Project	IEEE 802.16 Broadband Wireless Access Working Group < http://ieee802.org/16 >	
Title	Quasi-Random Ranging Code and Ranging Sub-channel Selection in OFDMA System.	
Date Submitted	2002-03-08	
Source(s)	KiHo Chung, DaeEop Kang, JungMin Ro Samsung Electronics Co. 416, Maetan-3dong, Paldal-gu Suwon-si, Gyeonggi-do, Korea	Voice: +82-31-279-5097 Fax: +82-31-279-5130 mailto: khchung@samsung.com , dave@samsung.com , clairero@samsung.com
Re:	IEEE C802.16a-02/33	
Abstract	This document contains the concept of Quasi-Random Selection of Ranging Code and Ranging Sub-channel for the 802.16a system	
Purpose	This proposal should be used for the Ranging design.	
Notice	This document has been prepared to assist IEEE 802.16. It is offered as a basis for discussion and is not binding on the contributing individual(s) or organization(s). The material in this document is subject to change in form and content after further study. The contributor(s) reserve(s) the right to add, amend or withdraw material contained herein.

Quasi-Random Ranging Code and Ranging Sub-channel Selection in OFDMA System

Figure 141 - Bandwidth Request in OFDMA

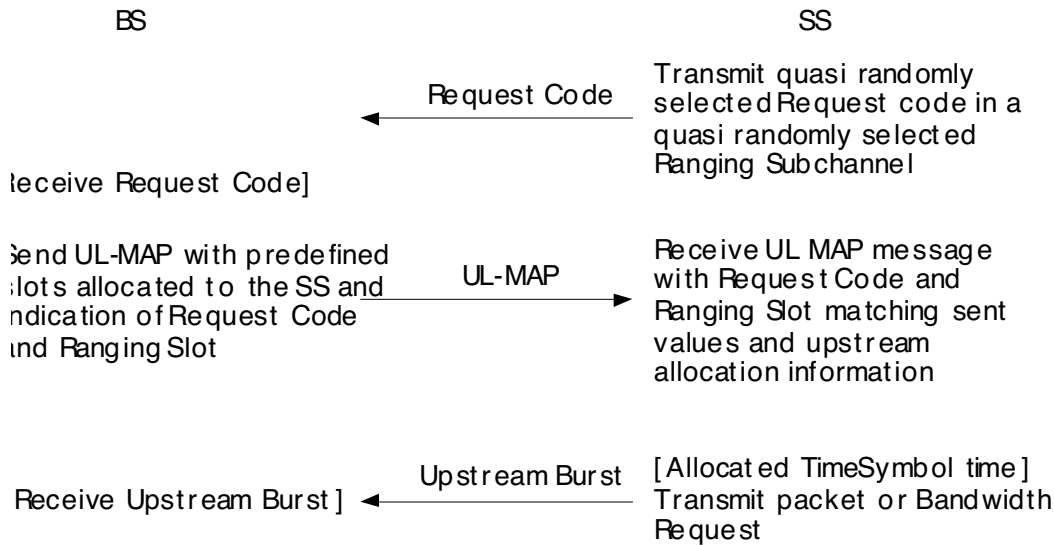
Replace the figure 141 of subsection 6.2.6.5 with the following
